**ZONING AMENDMENT, &  
SUBDIVISION STAFF REPORT****Date: February 7, 2008**

<b><u>APPLICANT NAME</u></b>	Blackwood, Inc., et al (Blacksher White-Spunner, Agent)
<b><u>SUBDIVISION NAME</u></b>	Hutson-Key Subdivision, Unit Two, Resubdivision of Lot3
<b><u>LOCATION</u></b>	Northwest corner of West I-65 Service Road South and Pleasant Valley Road, extending to the Northeast corner of Michael Boulevard and Hutson Drive, and extending to the South side of Key Street, 490'± West of West I-65 Service Road South
<b><u>CITY COUNCIL DISTRICT</u></b>	District 5
<b><u>PRESENT ZONING</u></b>	I-1, Light Industry
<b><u>PROPOSED ZONING</u></b>	B-3, Community Business
<b><u>AREA OF PROPERTY</u></b>	3 Lots/16.4± acres
<b><u>CONTEMPLATED USE</u></b>	<p>Subdivision approval to create 2 lots, and Zoning approval, and to rezone the site from I-1, Light Industry to B-3, Community Business to allow a hotel.</p> <p><b>It should be noted, however, that any use permitted in the proposed district would be allowed at this location if the zoning is changed. Furthermore, the Planning Commission may consider zoning classifications other than that sought by the applicant for this property.</b></p>

APPLICATION NU

# SITE PLAN

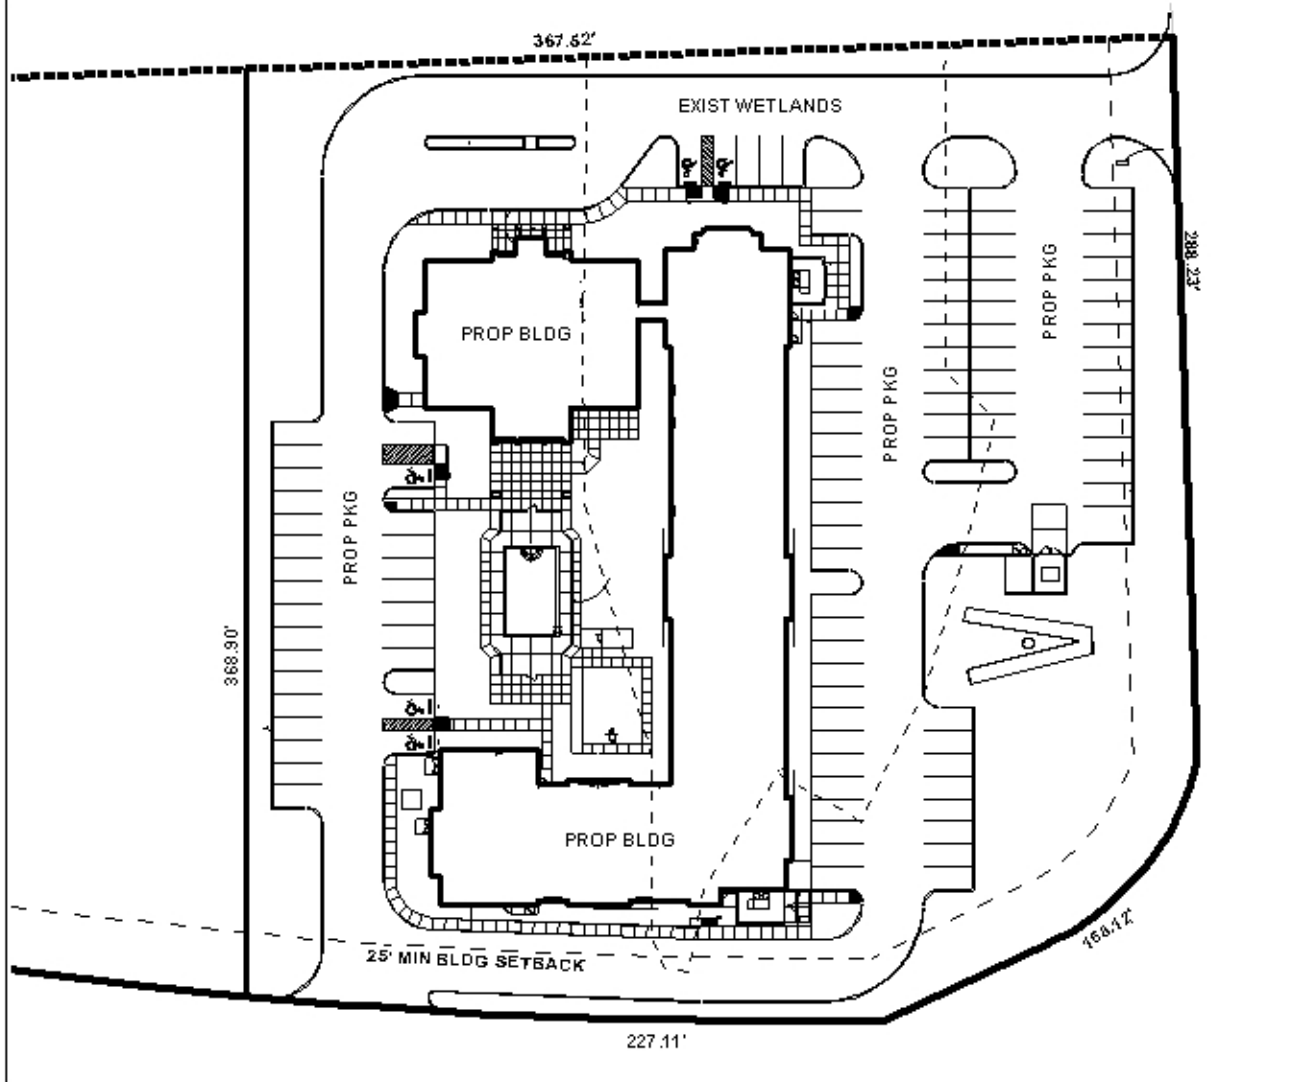
There are no issues relating to the site plan submitted, the applicant has address all points in determining the design of the extended stay hotel and fully complies with the Zoning Ordinance requirements.

## SUBDIVISION AND ZONING DETAIL

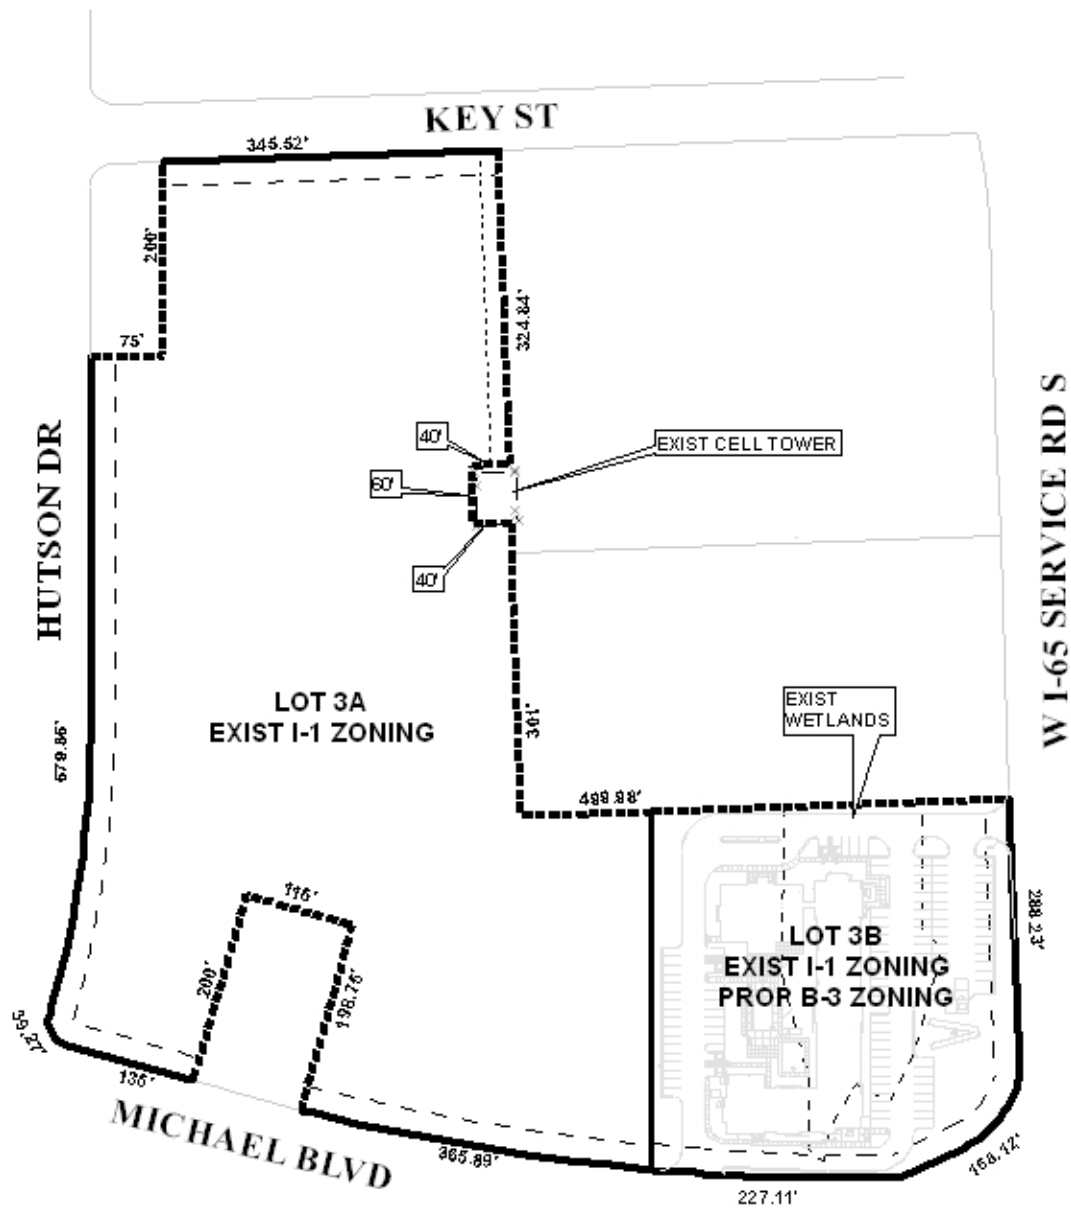
Access management is a concern due to the site fronting on five streets; therefore, Lot 3A should be limited to the existing curb cuts, Lot 3B should be limited to one curb-cut, to West I-65 Service Road South and one curb-cut to Pleasant Valley Road, with the size, design and location of all curb-cuts to be approved by Traffic Engineering and conform with AASHTO standards. The limiting of curb cuts to Lot 3A will encourage further subdivision of this 13± acre lot.

- 1) placement of a note on the final plat stating that Lot 3A be limited to the existing curb cuts, Lot 3B should be limited to one curb-cut, to West I-65 Service Road South and one curb-cut to Pleasant Valley Road, with the size, design and location of **all** curb-cuts to be approved by Traffic Engineering and conform with AASHTO standards.
- 2) the labeling of each lot with its size in square feet, or placement of a table on the plat with the same information;
- 3) compliance with Engineering comments;
- 4) placement of a note on the final plat stating that the maintenance of the detention common area is the responsibility of the property owners; and
- 5) full compliance with all other municipal codes and ordinances.
